## HISTORIC AND DESIGN REVIEW COMMISSION

May 01, 2024

**HDRC CASE NO:** 2024-127  
**ADDRESS:** 325 E LOCUST  
**LEGAL DESCRIPTION:** NCB 1738 BLK 3 LOT 6  
**ZONING:** MF-33, H  
**CITY COUNCIL DIST.:** 1  
**DISTRICT:** Tobin Hill Historic District  
**APPLICANT:** Ricardo A McCullough  
**OWNER:** Raul Osio | Tobin Hill Developments  
**TYPE OF WORK:** Conceptual review of rear addition removal, two-story rear addition construction, fenestration modifications, front porch addition and modifications, roof form and material modifications, rear parking installation, and landscape modifications

## EXISTING AND DEMOLITION PLAN

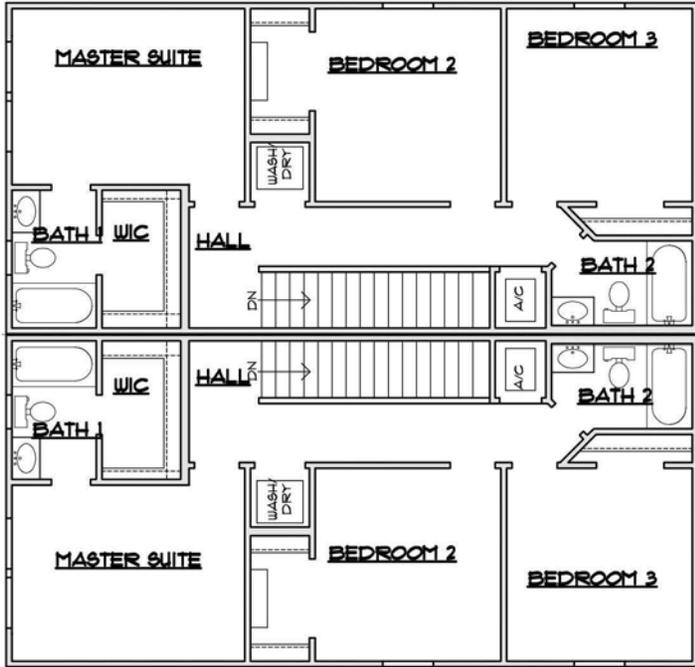
- e. PARTIAL DEMOLITION OF REAR ADDITION – The applicant is requesting conceptual approval to remove the existing CMU rear addition. This section of the structure first appears on the 1973 Historic Aerials map. Staff finds the demolition of the CMU rear addition generally conforms to the UDC.

Item 1: Staff recommends conceptual approval of partial demolition of the rear addition, based on findings a through e.

CONCEPTUAL 1st AND 2nd FLOOR PLANS

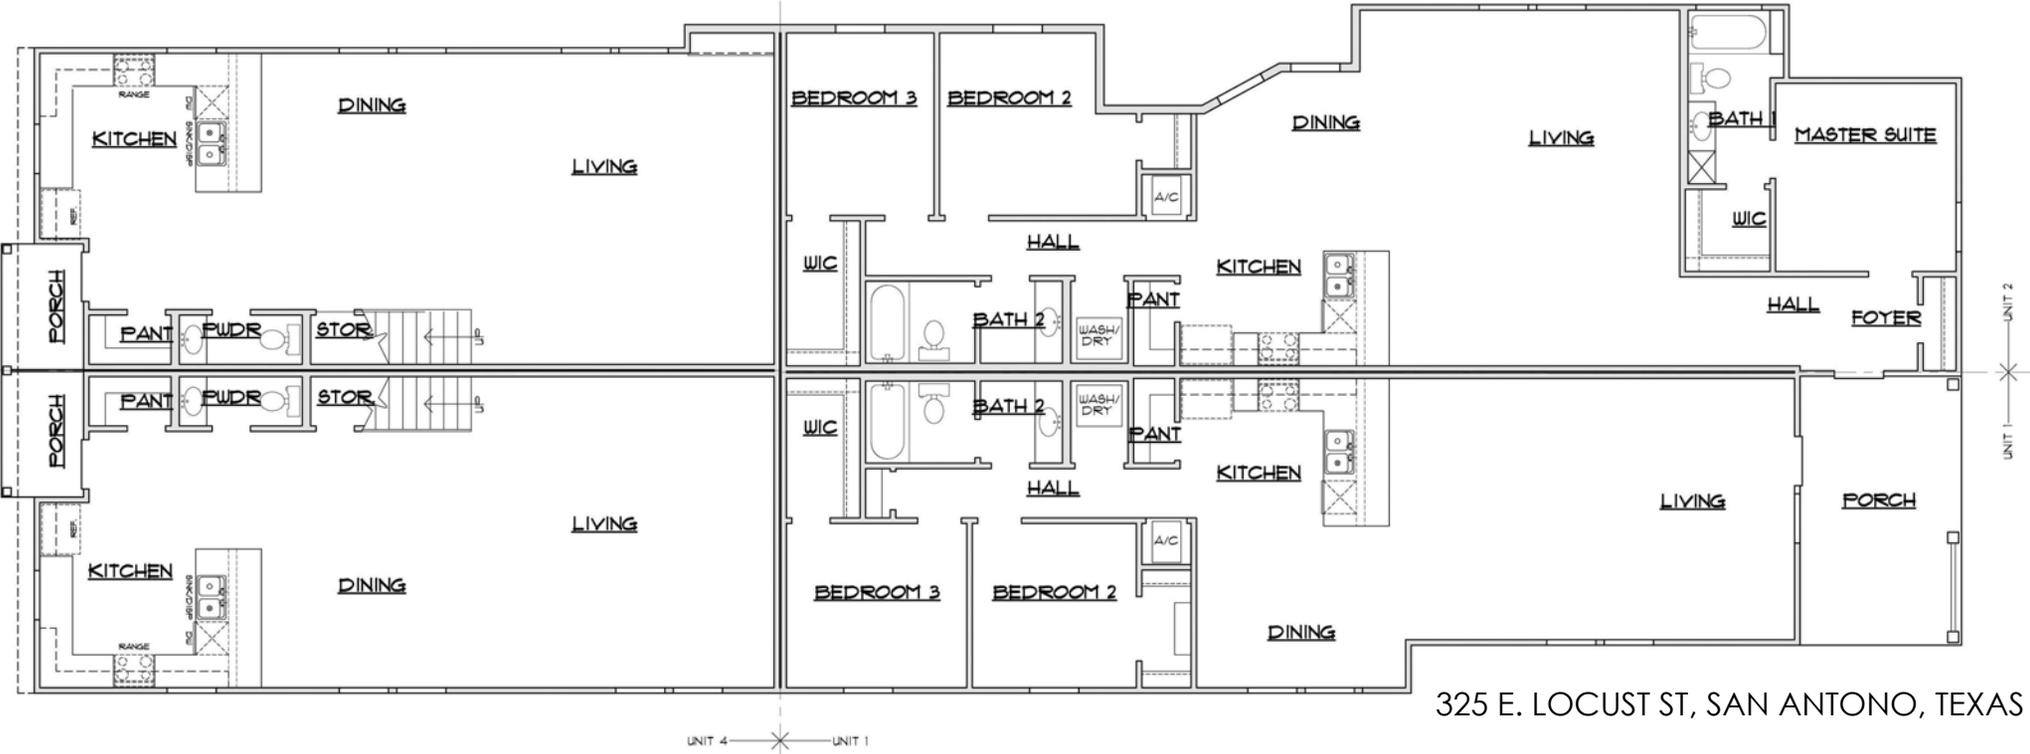
- f. TWO-STORY REAR ADDITION (LOT COVERAGE) – The applicant has proposed to construct a two-story rear addition. The applicant has not provided the total percentage of lot coverage to staff for review at this time. According to the Historic Design Guidelines, the building footprint for new construction should be limited to no more than 50 percent of the total lot area, unless adjacent historic buildings establish a precedent with a greater building to lot ratio. A building footprint should respond to the size of the lot. Staff finds that the size of the proposed addition is generally appropriate considering the two-story addition would use the same footprint currently existing on the property.

- g. TWO-STORY REAR ADDITION (MASSING & FOOTPRINT) – The applicant has proposed to construct a two-story rear addition. The existing primary structure is a 1-story structure. Additions 1.B.i stipulates residential additions should be designed to be subordinate to the principal façade of the original structure in terms of scale and mass. Additions 2.B.iv states the building footprint should respond to the size of the lot. An appropriate yard to building ratio should be maintained for consistency within historic districts. Residential additions should not be so large as to double the existing building footprint, regardless of lot size. Staff finds the proposal does not conform to Guidelines.

PROPOSED SITE PLAN

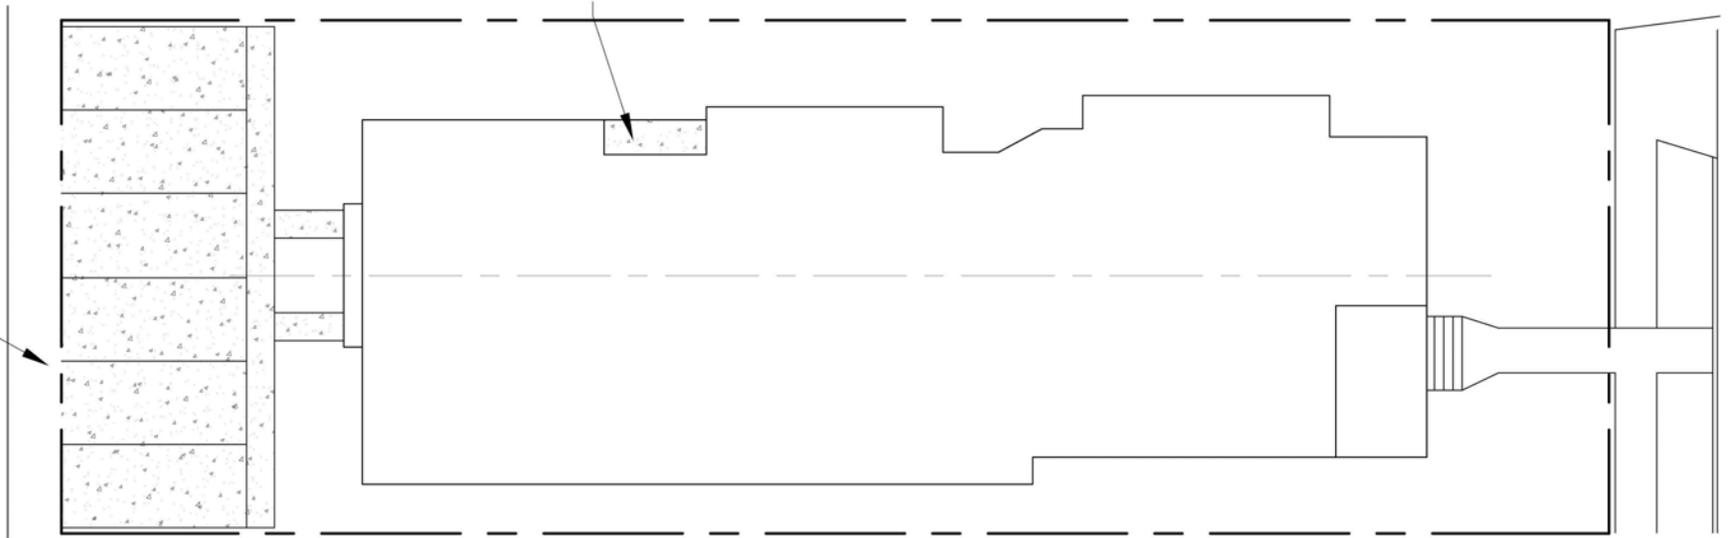
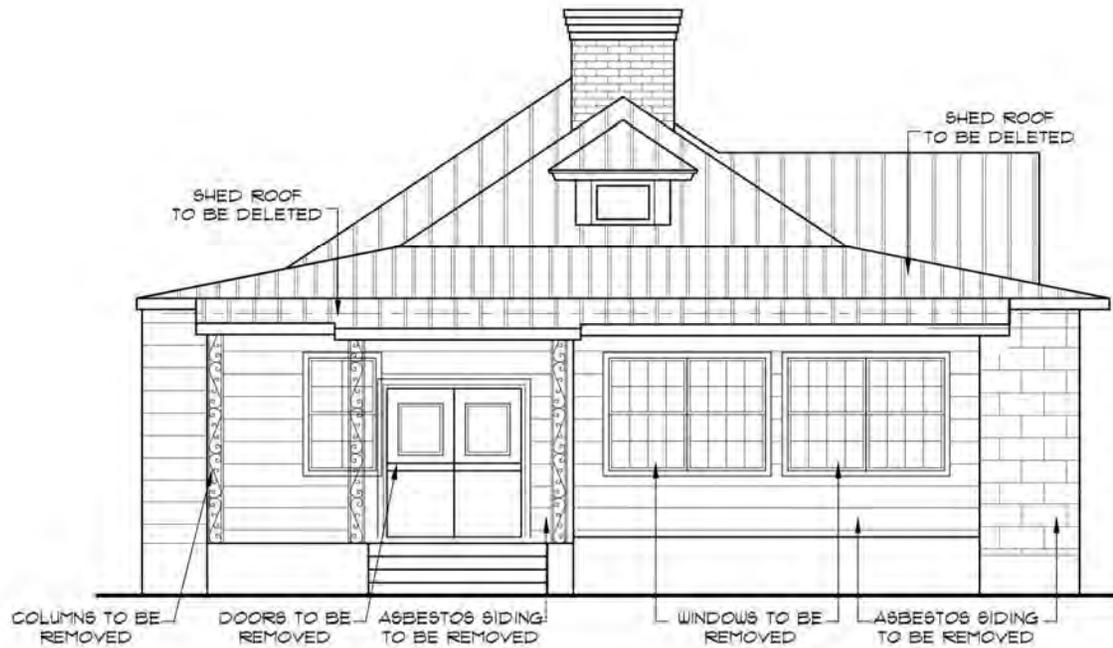
- u. **LANDSCAPE MODIFICATIONS** – The applicant is requesting conceptual approval to replace existing grass on the east and west sides of the structure with gravel. Site Elements 3.B.ii. states new pervious hardscapes should be limited to areas that are not highly visible and should not be used as wholesale replacement for plantings, and if used, small plantings should be incorporated into the design. Staff finds the proposed landscape modifications appropriate; however, the applicant should incorporate small plantings on the east and west sides of the property.

Item 7: Staff recommends conceptual approval of the landscape modifications, based on findings a through c and finding u, with the following stipulations:

- i. That the applicant includes plantings within the proposed gravel area.
- ii. That the applicant installs gravel not exceeding 2 inches in size.
- iii. That the applicant installs gravel natural in color.

PROPOSED FRONT ELEVATION

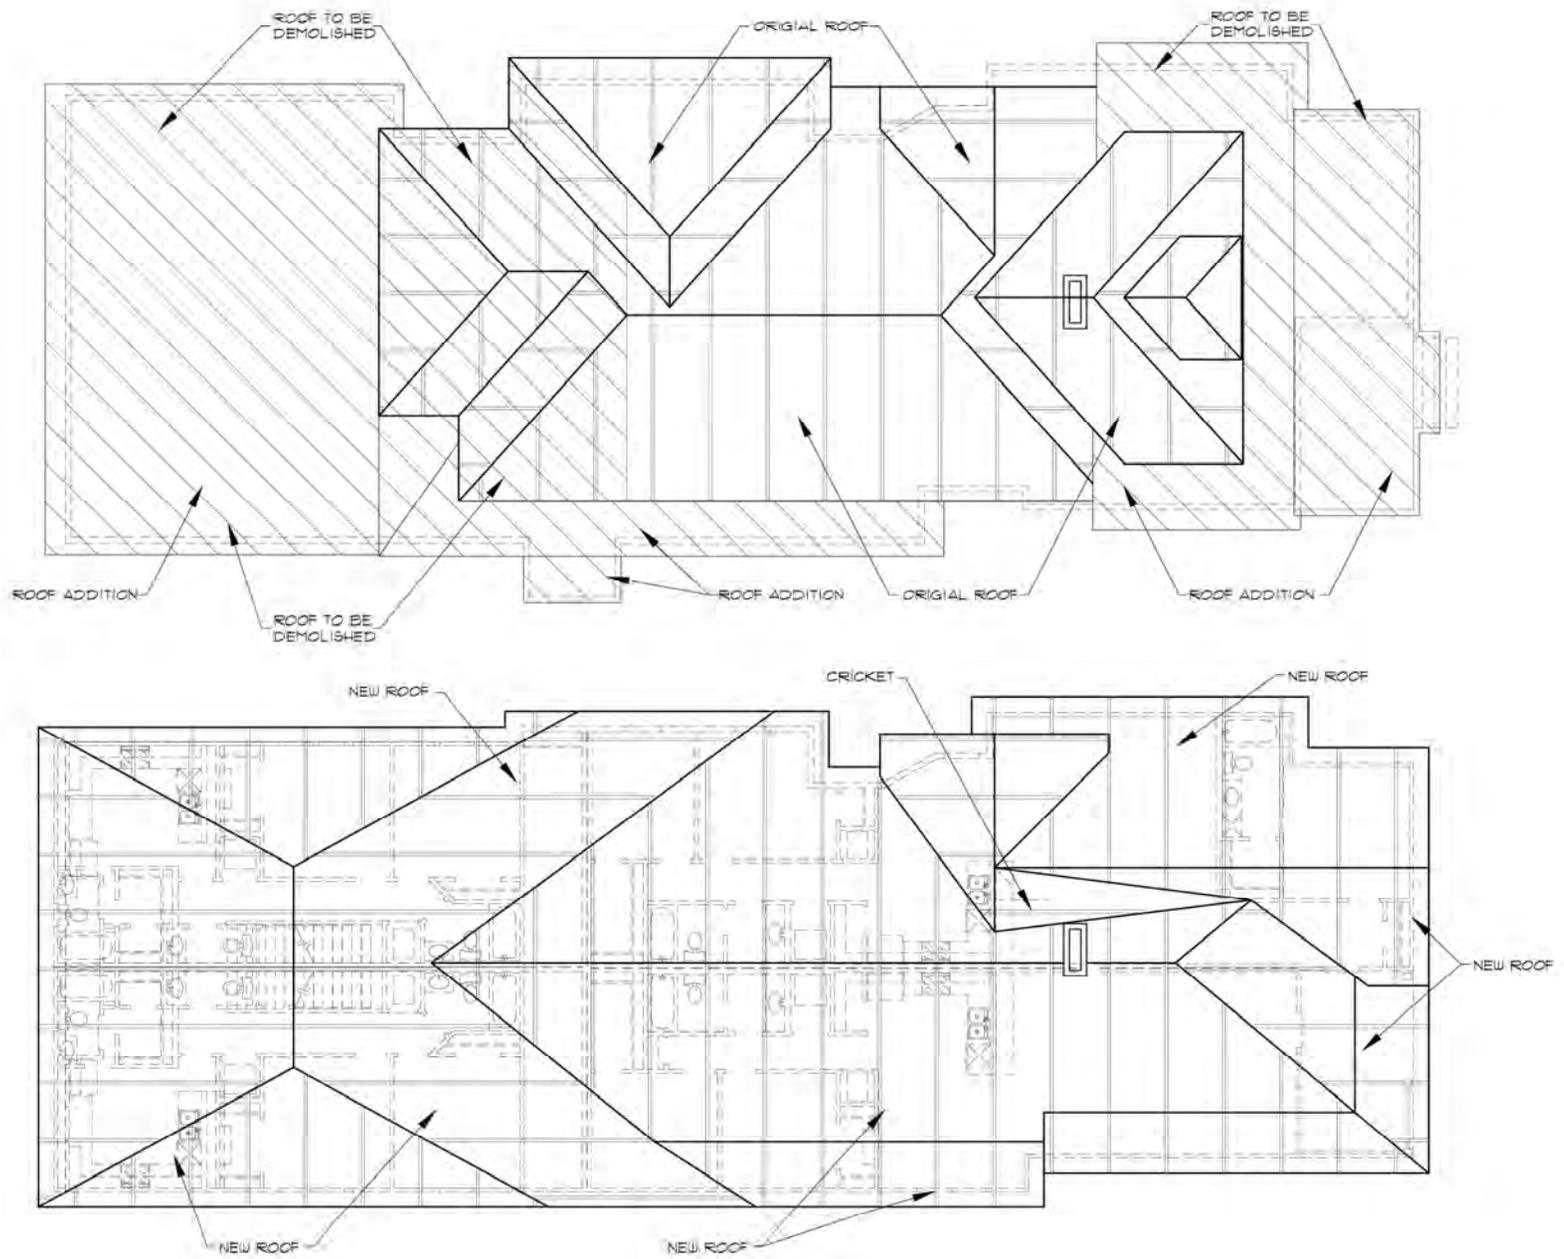
- q. **FRONT PORCH MODIFICATIONS & FRONT ADDITION** – The applicant is requesting conceptual approval to modify the existing front porch and replace the existing front addition with a new front-facing gabled addition. Modifications include the replacement of decorative metal columns with 8x8 square wood columns, and new side door opening, and railing installation. Exterior Maintenance and Alterations 7.B.iii. states to replace in-kind porches and related elements, such as ceilings, floors, and columns, when such features are deteriorated beyond repair, and when in-kind replacement is not feasible, the design should be compatible in scale, massing, and detail while materials should match in color, texture, dimensions, and finish. Exterior Maintenance and Alterations 7.B.v. states to reconstruct porches based on accurate evidence of the original, such as photographs, and if no such evidence exists, the design should be based on the architectural style of the building and historic patterns. Additions 1.A.i. states to site residential additions at the side or rear of the building whenever possible to minimize views of the addition from the public right-of-way and that an addition to the front of a building would be inappropriate. Staff finds the proposed front porch modifications do not conform to Guidelines. Sanborn Maps provide evidence to the original front porch configuration. Alterations to the porch should be based on existing evidence, and new front additions should be eliminated from the design.

EXISTING AND PROPOSED ROOF PLAN

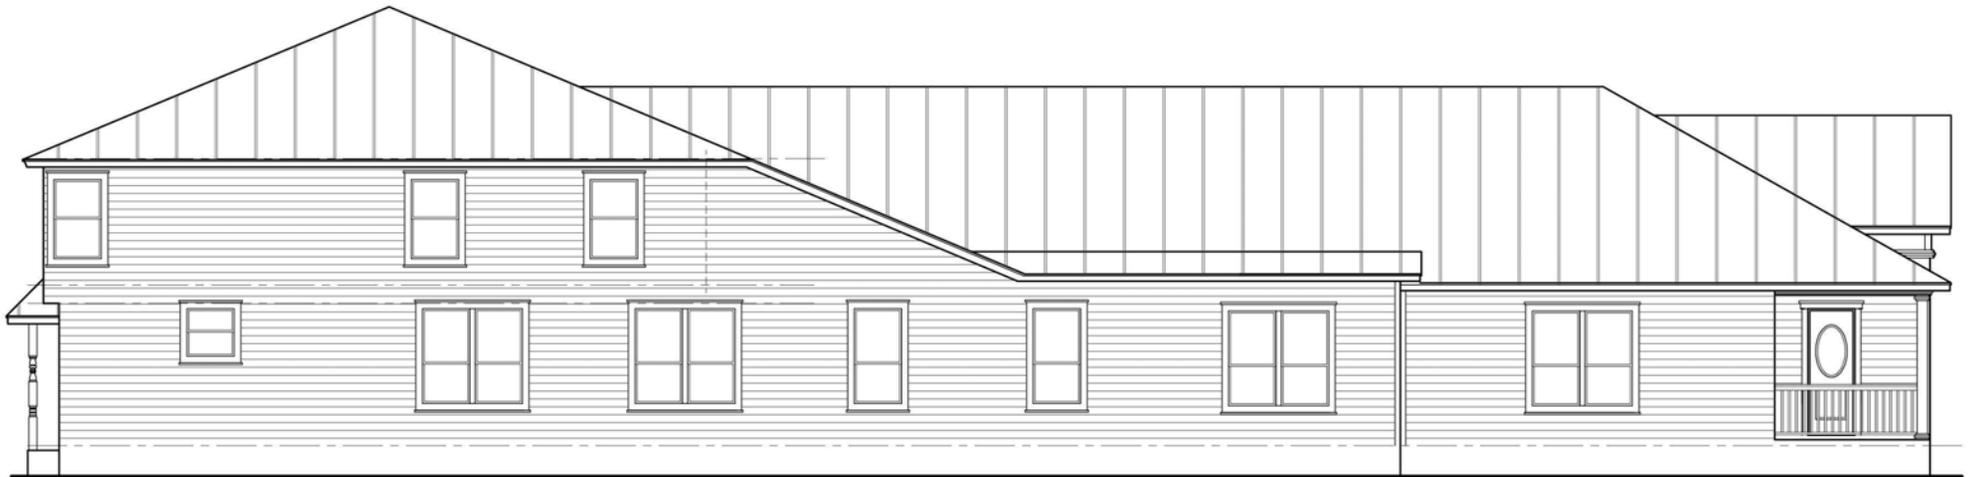
- r. **ROOF FORM & MATERIALS MODIFICATIONS** – The applicant is requesting conceptual approval to modify the existing roof form by removing the front-facing dormer, adding a front-facing gable, and removing an east and north facing hipped roof overhangs. Additionally, the applicant is requesting conceptual approval to remove the existing decorative pressed-tin metal roof and replace with a standing seam metal roof. Exterior Maintenance and Alterations 3.B.ii. states to preserve the original shape, line, pitch, and overhang of historic roofs when replacement is necessary. Exterior Maintenance and Alterations 3.B.iii. states to preserve and repair distinctive roof features such as cornices, parapets, dormers, open eaves with exposed rafters and decorative or plain rafter tails, flared eaves or decorative purlins, and brackets with shaped ends. Exterior Maintenance and Alterations 3.B.iv. stipulates to replace roofing materials in-kind whenever possible when the roof must be replaced and to match new roofing materials to the original materials in terms of their scale, color, texture, profile, and style, or select materials consistent with the building style, when in-kind replacement is not possible. Staff finds the proposed roof form modifications do not conform to Guidelines. While the proposed replacement roof conforms to the standing seam metal roof stipulations found in Chapter 2, Exterior Maintenance and Alterations, staff finds that the proposed standing seam metal roof does not conform with Guidelines as it constitutes a change in material, texture, and style.

- s. **REAR CHIMNEY REMOVAL** - The applicant is requesting conceptual approval to remove the existing rear chimney. Exterior Maintenance and Alterations 3.B.iii. states to preserve and repair distinctive roof features. Staff finds the removal of the rear chimney does not conform to Guidelines.

PROPOSED SIDE AND REAR ELEVATIONS

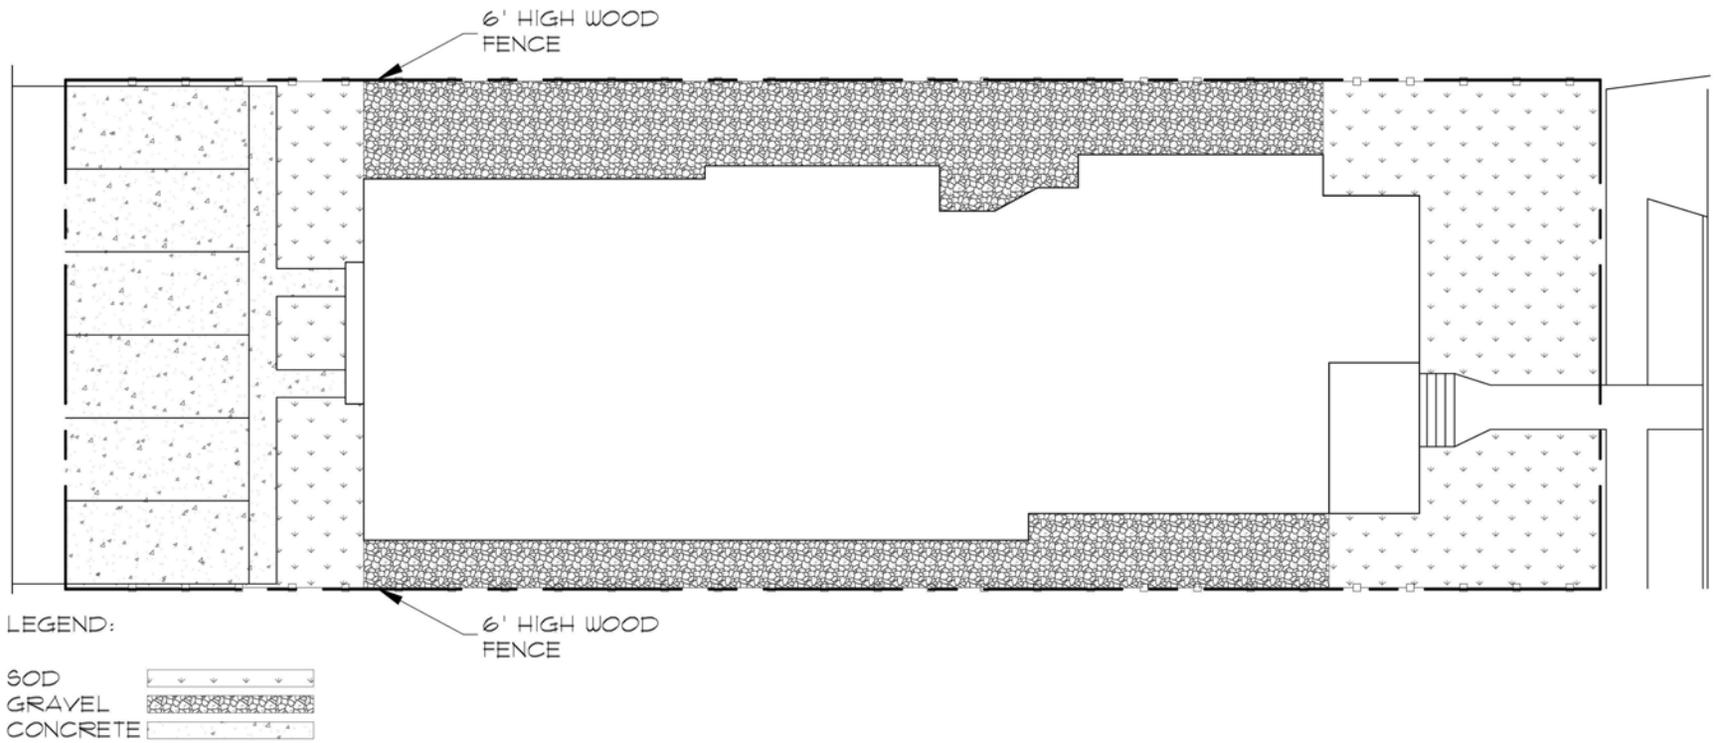
- h. TWO-STORY REAR ADDITION (ROOF FORM) – The applicant has proposed to install a hipped roof to the proposed two-story rear addition. The roof form of the addition will be visible from the public right-of-way. Additions 1.A.iii stipulates that residential additions should utilize a similar roof pitch, form, overhang, and orientation as the historic structure. Staff finds the proposed roof form generally appropriate.

- n. TWO-STORY REAR ADDITION (ARCHITECTURAL DETAILS) – The applicant has proposed to construct a two-story rear addition. Additions 4.A.ii states additions should incorporate architectural details that are in keeping with the architectural style of the original structure. Details should be simple in design and compliment the character of the original structure. Architectural details that are more ornate or elaborate than those found on the original structure should not be used to avoid drawing undue attention to the addition. Additions 4.A.iii states applicants should consider integrating contemporary interpretations of traditional designs and details for additions. Use of contemporary window moldings and door surroundings, for example, can provide visual interest while helping to convey the fact that the addition is new. Additions 2.A.v recommends that for side or rear additions utilize setbacks, a small change in detailing, or a recessed area at the seam of the historic structure and new addition to provide a clear visual distinction between old and new building forms. Staff finds the proposed architectural details of the two-story rear addition does not conform to Guidelines.

- p. FENESTRATION MODIFICATIONS – The applicant is requesting conceptual approval to modify the existing fenestration patterns on the original footprint and later additions. The Historic Design Guidelines for Exterior Maintenance and Alterations 6.A.i. states to preserve existing window and door openings, to avoid enlarging or diminishing to fit stock sizes or air conditioning units, and to avoid filling in historic door or window openings. Exterior Maintenance and Alterations 6.A.iii. states to preserve historic windows. Exterior Maintenance and Alterations 6.B.iv. states to install new windows to match the historic or existing windows in terms of size, type, configuration, material, form, appearance, and detail when original windows are deteriorated beyond repair. Exterior Maintenance and Alterations 6.B.vii. states to replace non-historic incompatible windows with windows that are

Item 3: There is not sufficient information for staff to make a recommendation for modification to the structure's fenestration pattern. Staff recommends the applicant supply as-built drawings of these elevations and clearly demonstrate proposed changes to fenestrations and roof forms.
